Comparism new DRV8818 vs legacy A3977 MotorDriver

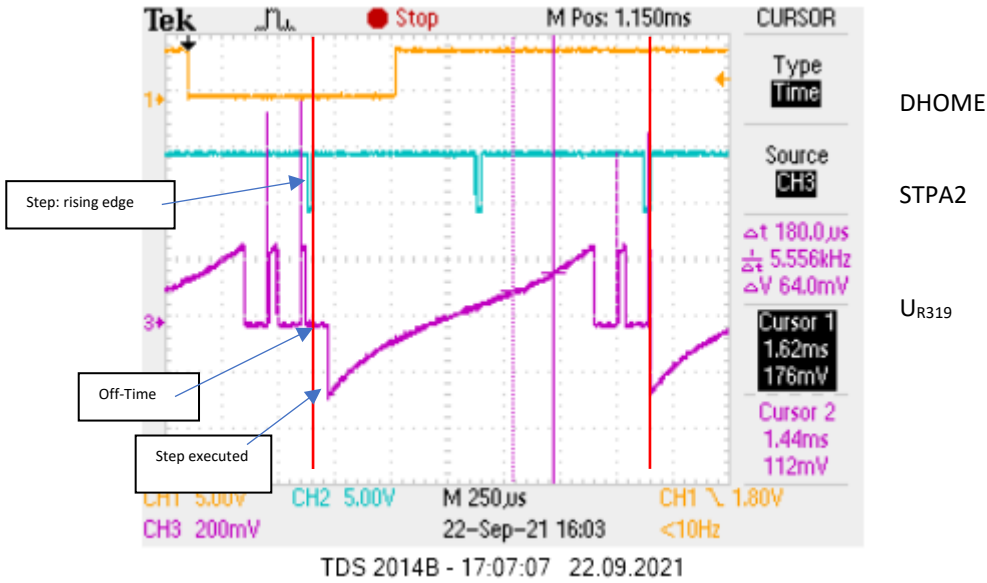
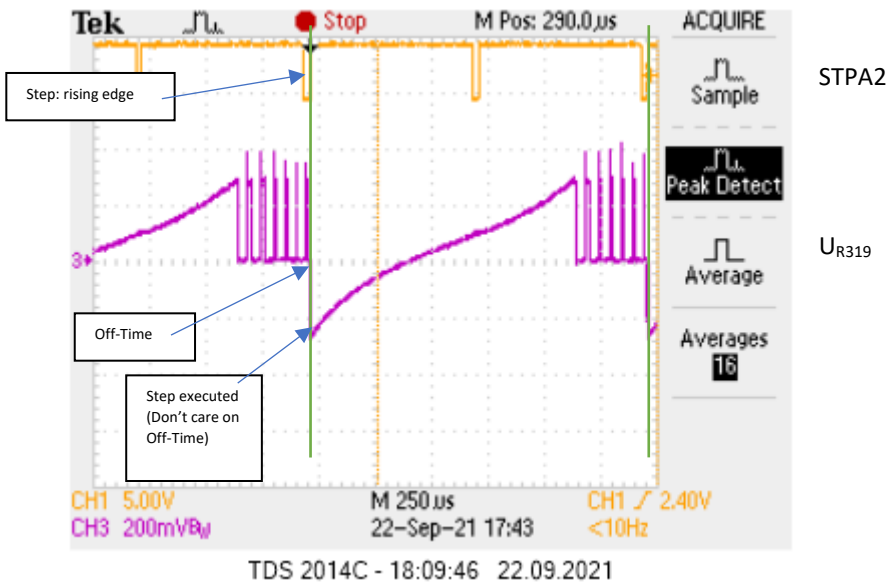
New MainBoard: Off Time is Prior to Step → leads into Jitter
 TI DRV8818

Legacy MainBoard: Step is Prior to Off Time → constant rotation
 Allegro A3977

Workaround

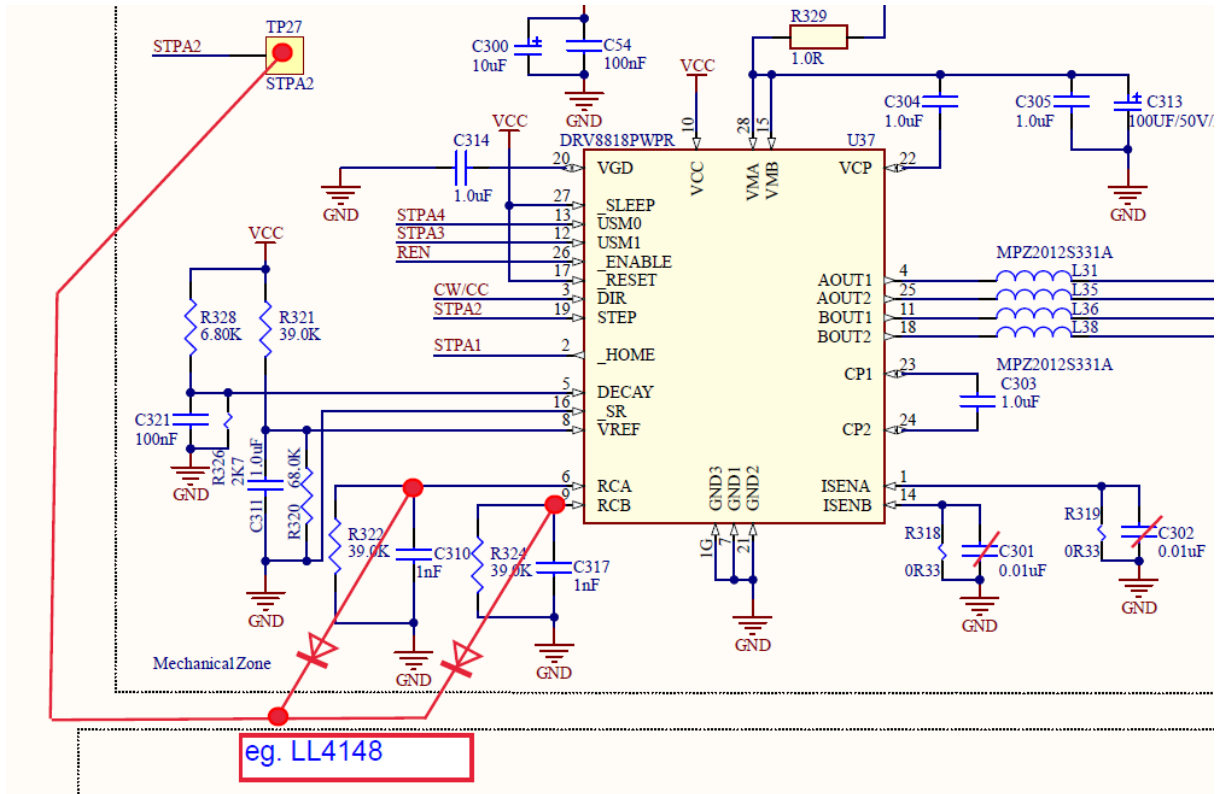
DRAFT. On my desk it works
